DEVELOPMENT REVIEW BOARD REPORT

11-DR-2006
Mountainside Plaza - M & I Bank

Request approval of a site plan and elevations for a new bank site.

CONCEPT LANDSCAPE PLAN

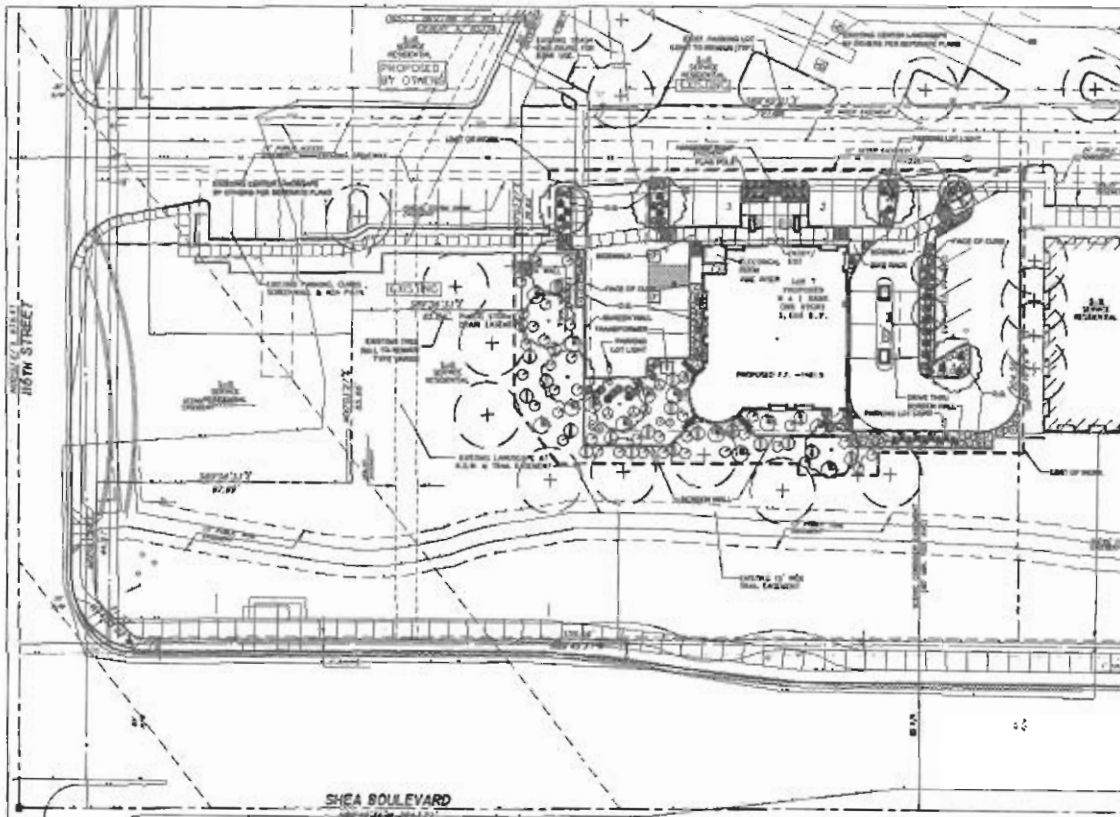
The Shoestring Acacia proposed in the parking lots is stipulated for replacement with a denser canopy tree that has stronger growth characteristic such as a Mesquite or Paolo Brea. The Shoestring Acacia is a good accent but is less effective as a canopy tree unless given substantial maintenance attention. The replacement of the Acacia is consistent with the previous stipulations for the overall commercial center. The other landscape design elements are consistent with the previous approval.

12. *The Shoestring Acacia species shall be replaced with either Mesquite or Palo Brea species as stipulated with 45-DR-2002.*

PRELIMINARY ELEVATIONS

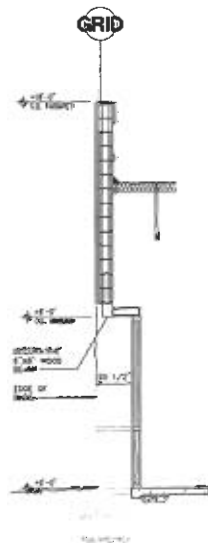
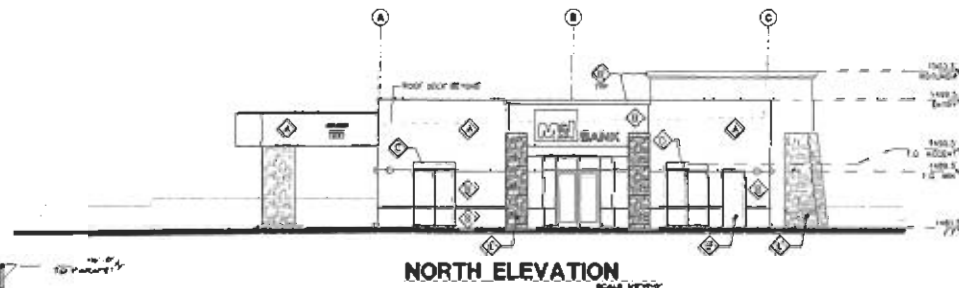
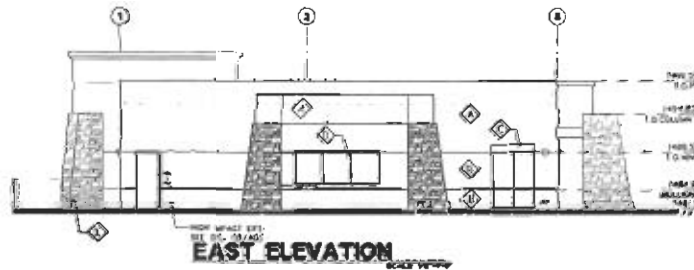
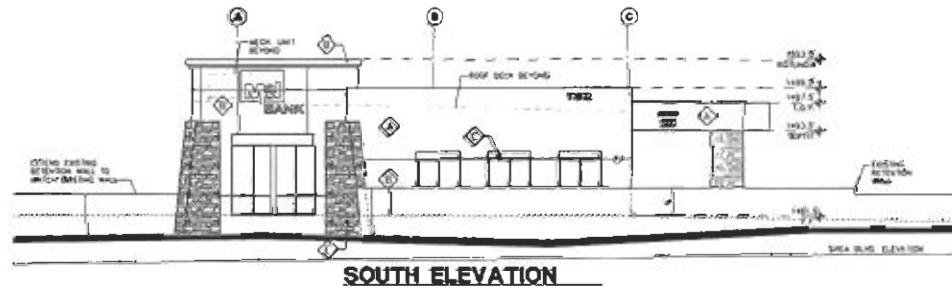
The pueblo architectural style is a continuation of the existing shopping center design. The windows are set deep into the walls for consistency with the adjacent pueblo style development, and to enhance the architectural style and provide shading for the glazing. The round element at the southwest corner of the building introduces a new feature to the pueblo styled commercial center, but it is not a significant distraction from the theme.

2. *The pneumatic tubes on the bank shall be integrated into column features to match the bank building canopy columns, or shall be constructed below grade; and all of other the associated pneumatic mechanical devices shall be finished to match the bank building.*
